**AGENDA
CITY OF CEDAR FALLS, IOWA
PLANNING AND ZONING COMMISSION MEETING
WEDNESDAY, JUNE 10, 2020
5:30 PM AT CITY HALL**

- 2. **Downtown Site Plan Review – Community Bank and Trust**
Location: 312 W. 1st Street
Applicant: CB&T – owner; VJ Engineering – Civil Engineer; Emergent Architects
Previous discussion: 3/11/20 (plan deferred; new building design is now proposed)
Recommendation: Discussion and Recommend Approval
P&Z Action: Review and make a recommendation to the City Council

TO: Planning and Zoning Commission
FROM: Karen Howard, Planning & Community Services Manager
DATE: June 3, 2020
SUBJECT: Site Plan Review: 312 W. 1st Street

REQUEST: Request to approve the Site Plan for 312 W. 1st Street (Case #SP19-017)

EXTERIOR
ELEVATIONS

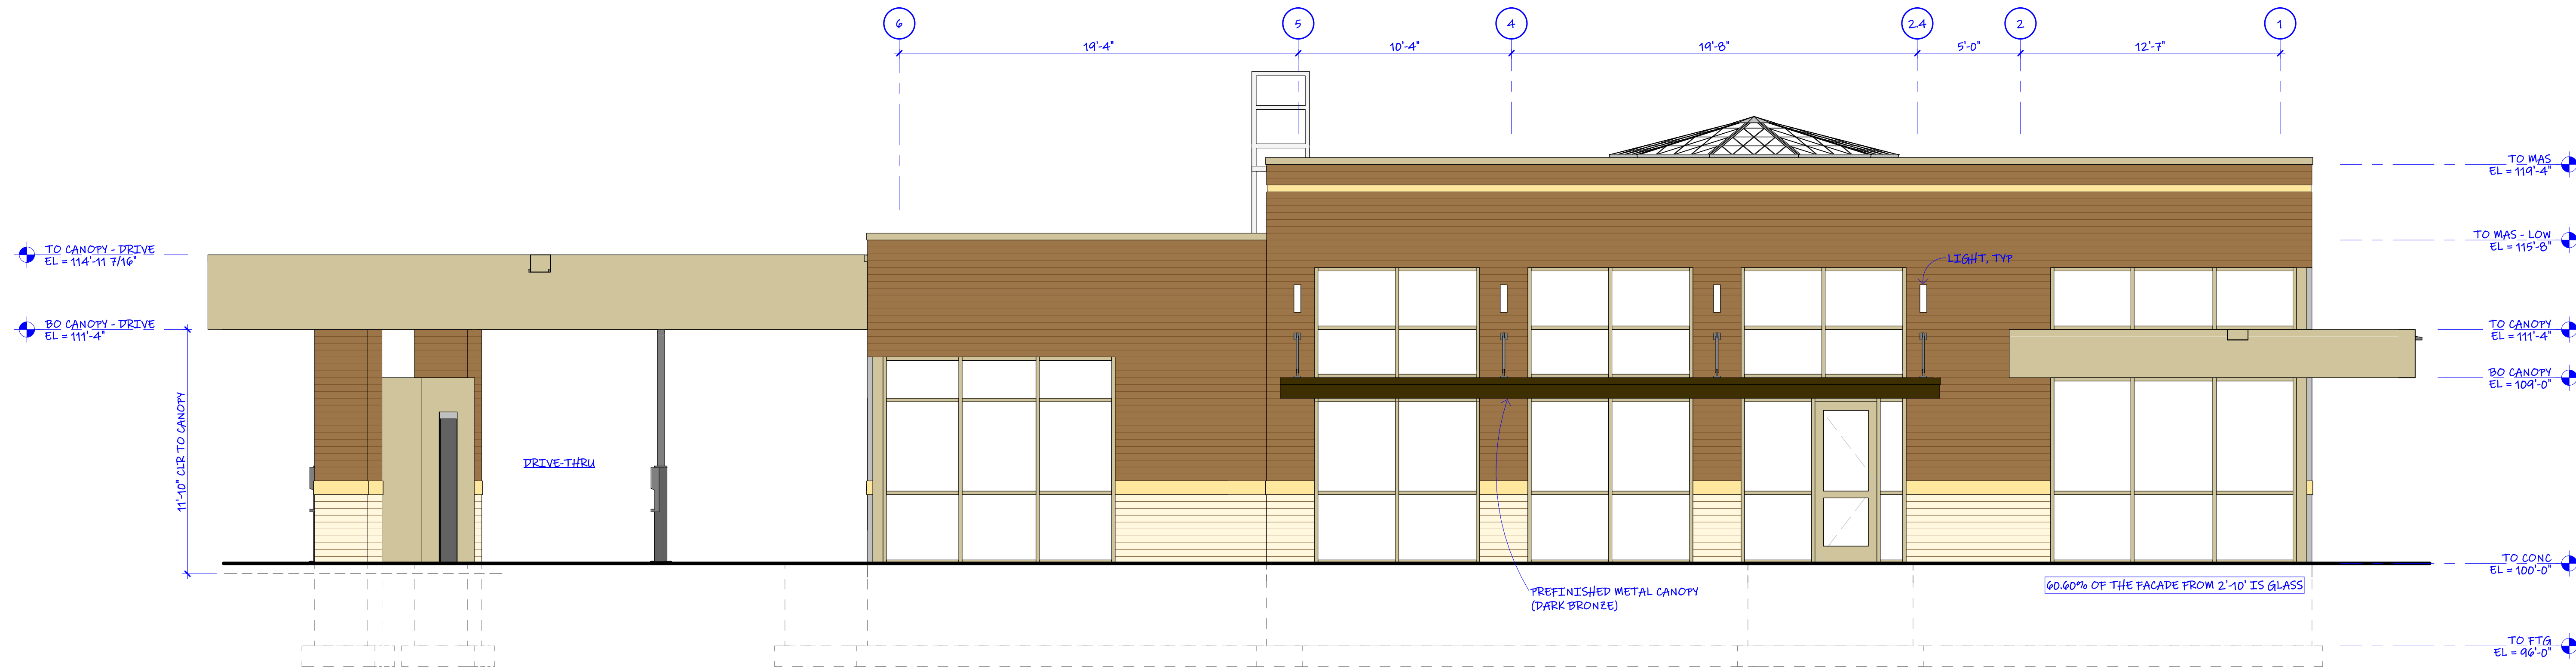
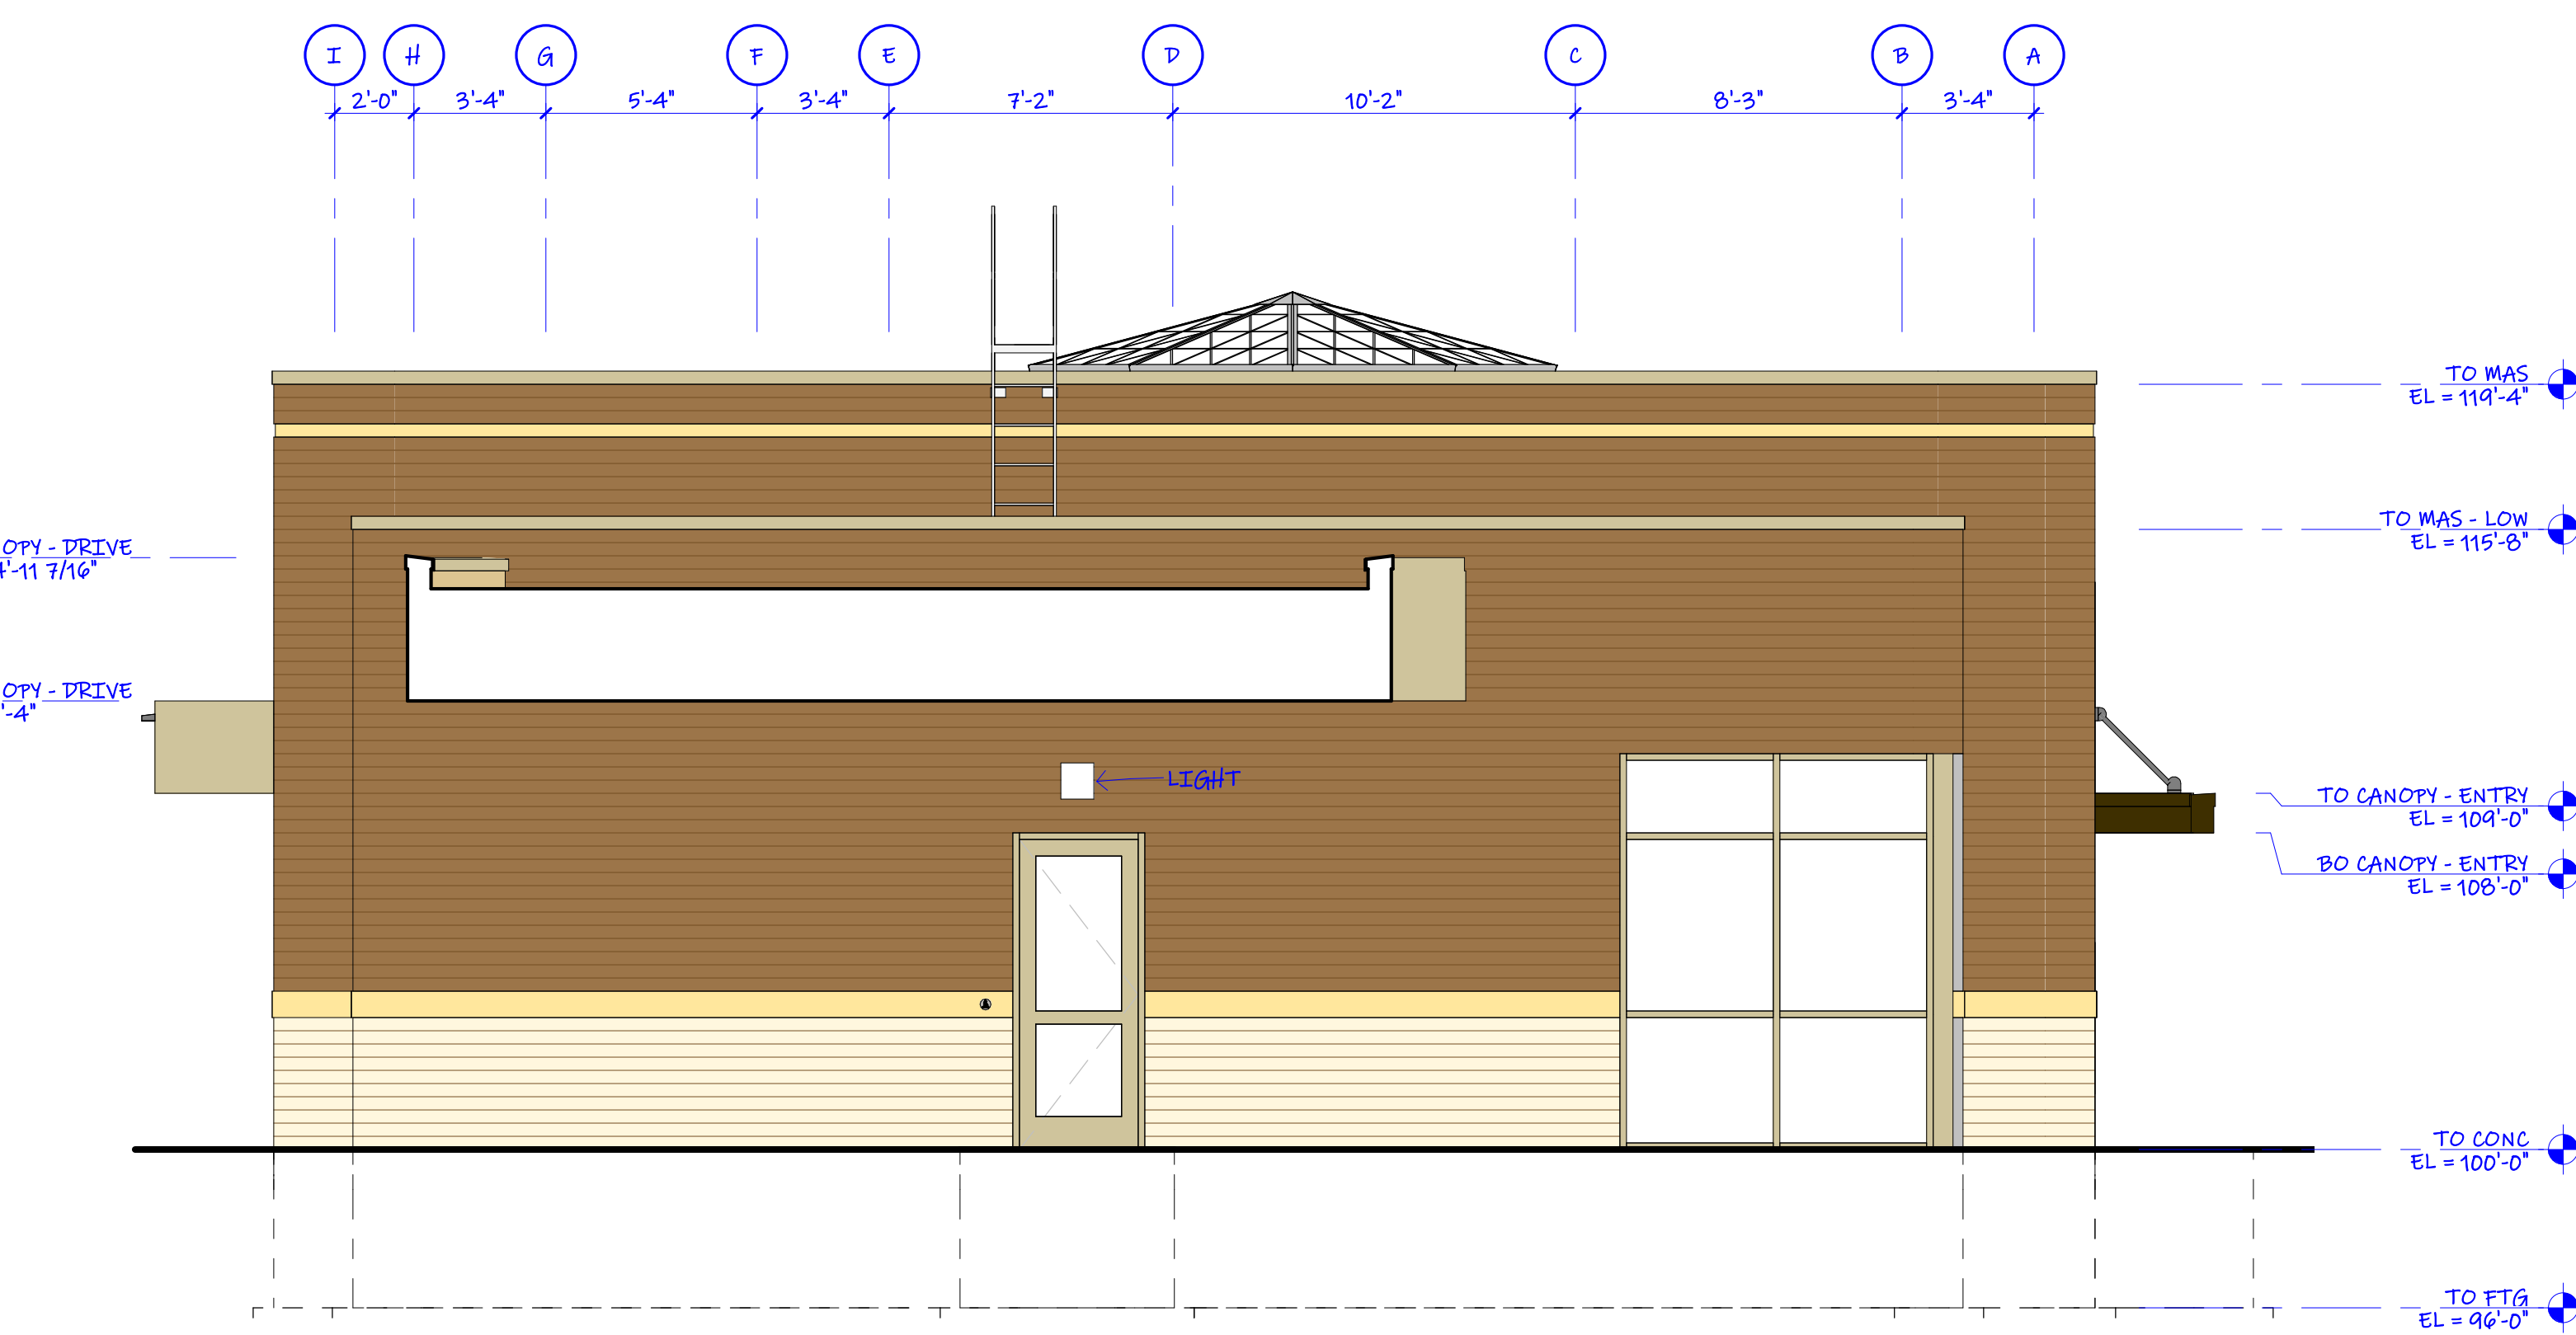
The proposed street-facing bank facades are designed with a rhythm of alternating window openings and solid brick surfaces typical of a modern storefront building. The west elevation has extensive window coverage as the bank desires to showcase this façade as a main entrance for customers arriving by car. The south side of the building has fewer openings as it will be largely shielded from view by the drive-through facility. **Staff finds that the proposed design meets the standard.**

The proposed building includes a more traditional pattern of storefront windows than the previous design, which featured a large curtain wall of glass concentrated in one location. The revised design as described above includes a pattern of storefront window openings along the street-facing façade. The architect has calculated the window coverage along the Clay Street façade, which is the primary street façade, at 60.6%. Along the secondary street-facing façade along 1st Street the window coverage is 66.3%. The window glass is clear and transparent glass with a Low-E coating to enhance energy efficiency. The visible light transmission is fairly high at 72%, which will allow views into the interior.

The applicant has requested a minor adjustment to the window coverage standard from the 70% required. As stated above, the zoning ordinance allows such a request to be considered if there are characteristics of the site or building that makes it difficult or infeasible to meet the requirements of the CBD Overlay. Looking at the floor plan, it is clear that the bank has maximized window coverage around three sides of the building in locations that do not interfere with the needs for storage, vault space, and work areas. Windows are concentrated at the street corner as recommended in the code standard. Staff also notes that the windows include an additional bank of transom windows to allow light into the interior and additional verticality to the one story façade.

The building is constructed with two different colors of brick. The building meets the requirement that at least 50% of the facades be comprised of brick, stone or terra cotta. Two different metal canopy designs are used, which help define the separate modules of the façade. **Criterion is met.**

The proposed bank has two entries into the building. The west entry is adjacent to the parking lot. The east entry is along the Clay Street, which is designated in the code as the primary street. This eastside entrance provides access for pedestrians traveling along the public sidewalk. **Criterion is met.**

Wall signage is identified on the north and west walls of the building. These are internally illuminated wall signs. The proposed signs meet the requirements for

Given the size of the building and its location at a street corner, staff is in support of a minor adjustment to the window coverage standard as shown on the proposed plans.
